Building Permit Application

LOT 13 BUILDING PERMIT PLOT PLAN

WALKER
MEADOWS
LOT 13
1037 STEPPING PLACE
PLAT #24974-24979
DDC JOB#: 12064.3
DATE: 12/06/19
SCALE: 1"=30'
CHK. BY: PGC
DRN. BY: LJC

LOT 13
 BUILDING PERMIT PLOT PLAN

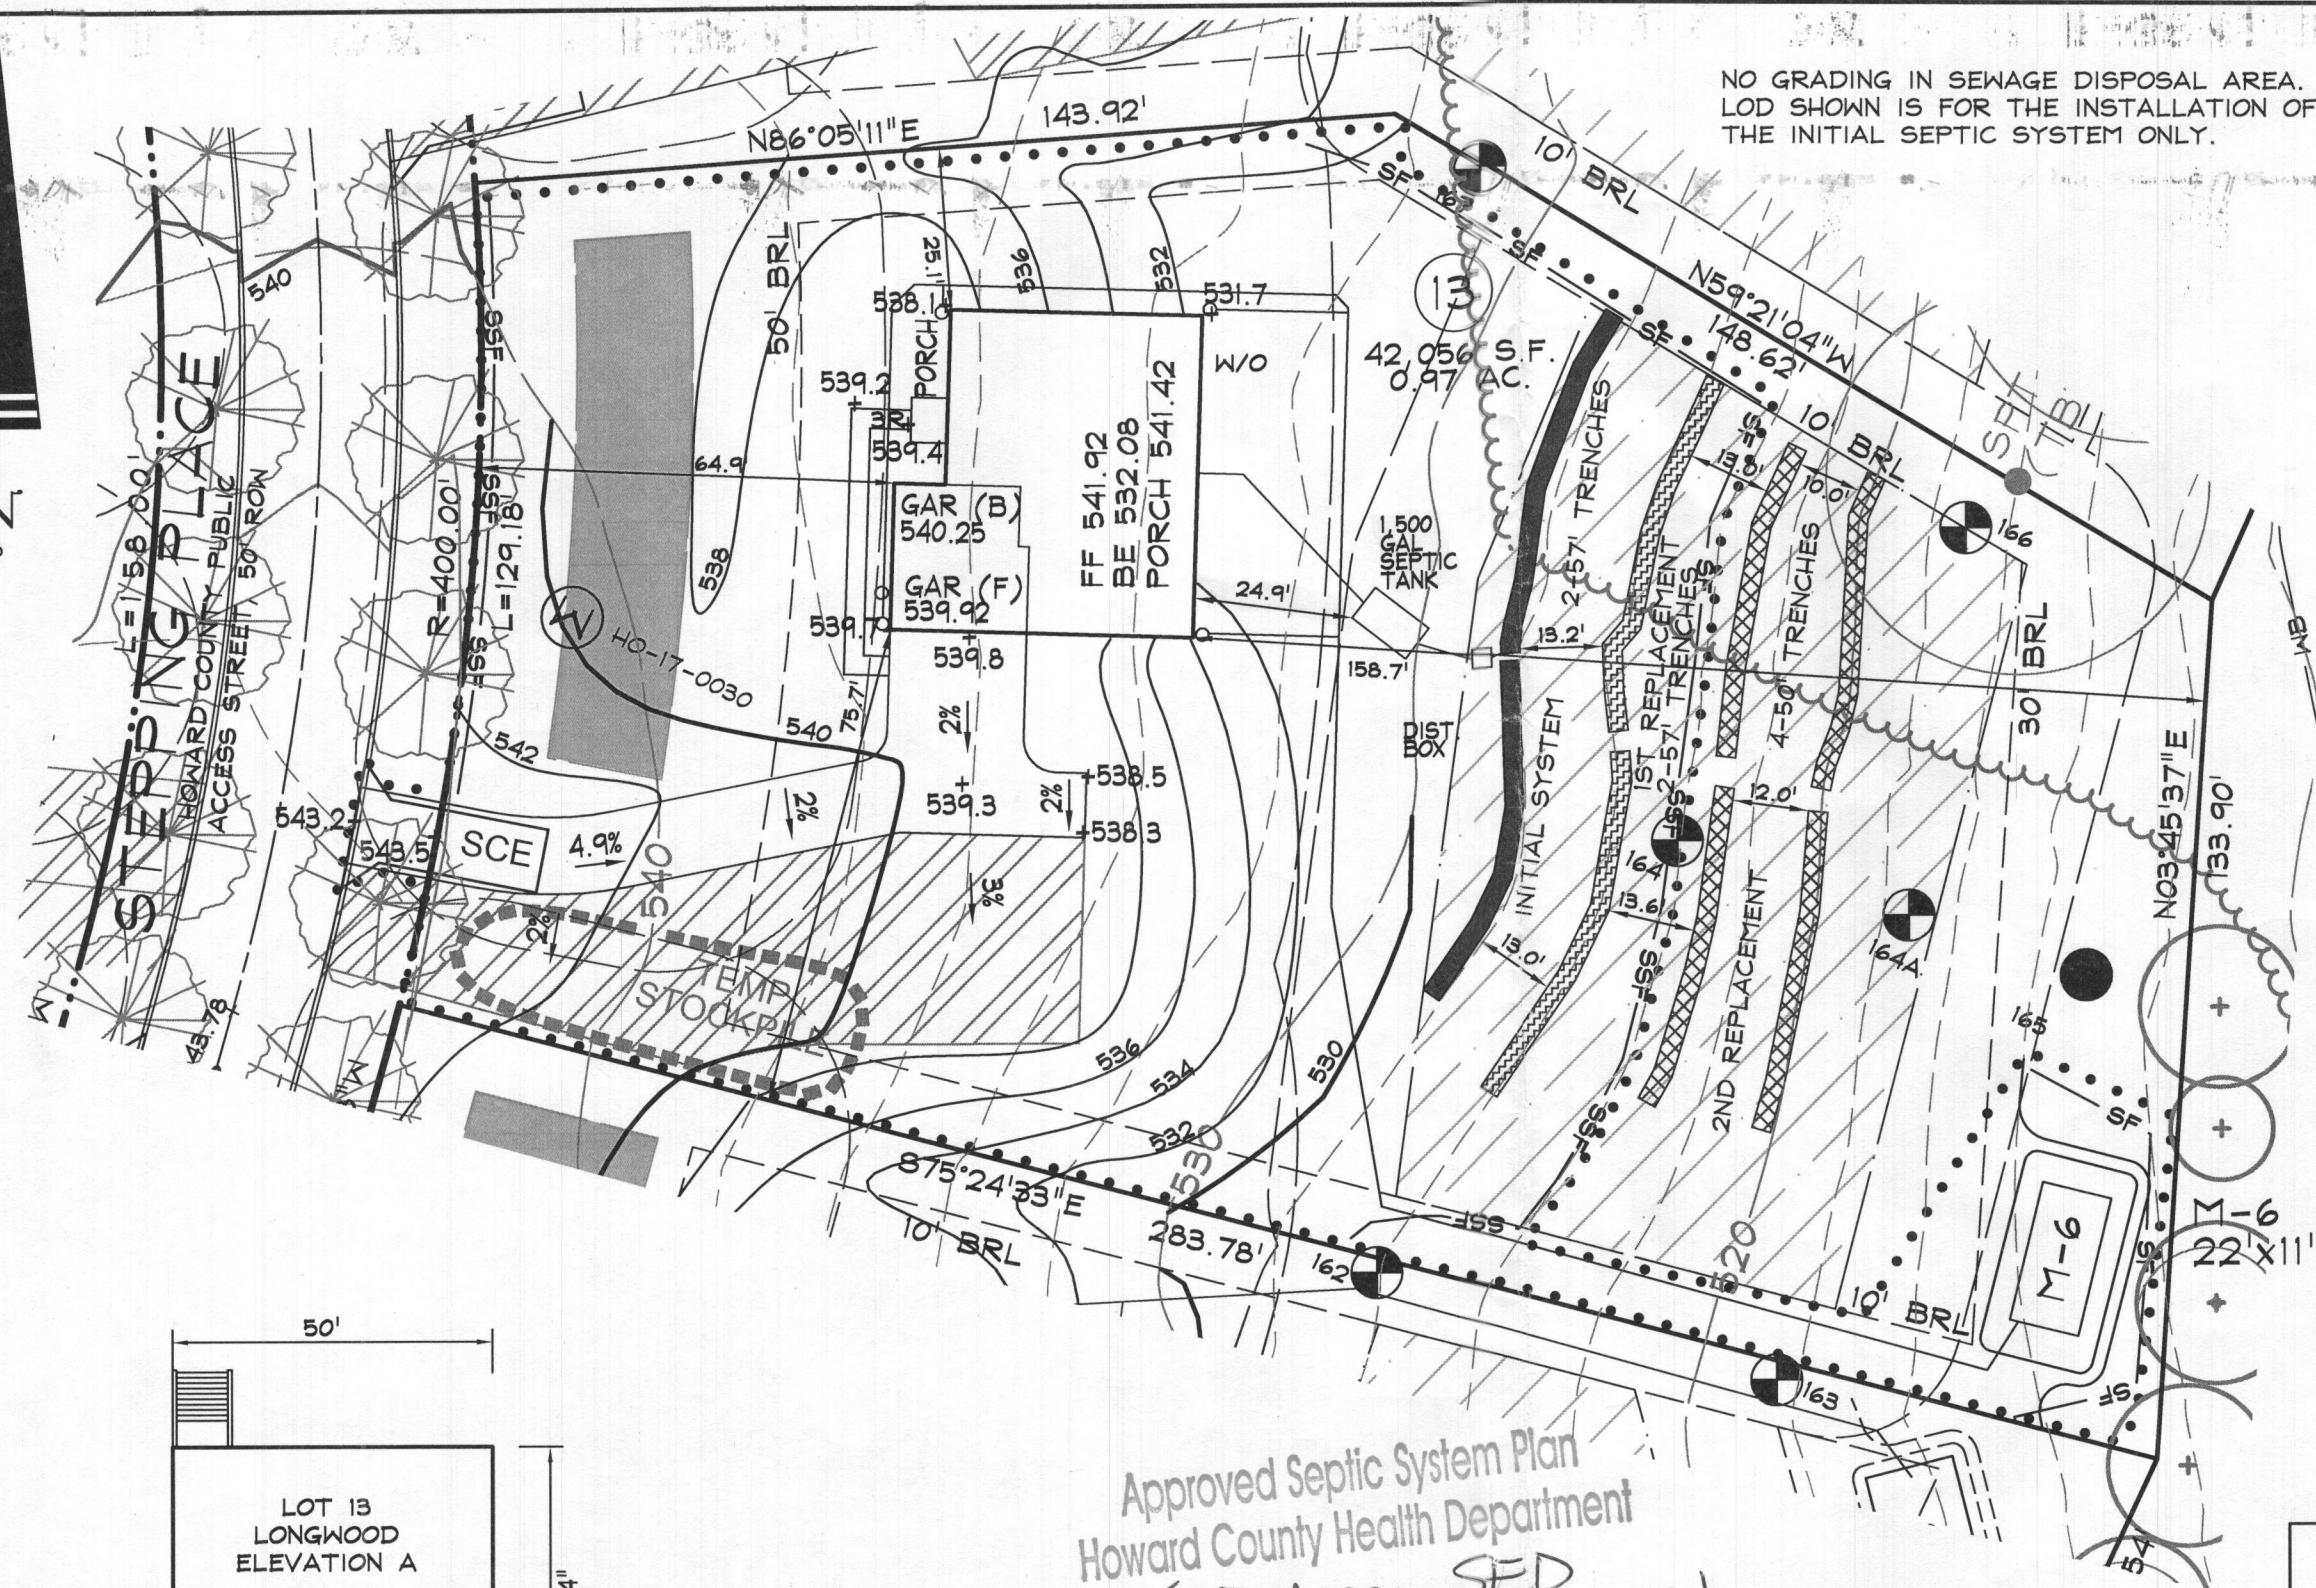
Date: 1-16-2020
 Comments: relocate septic tank
 # B19004354
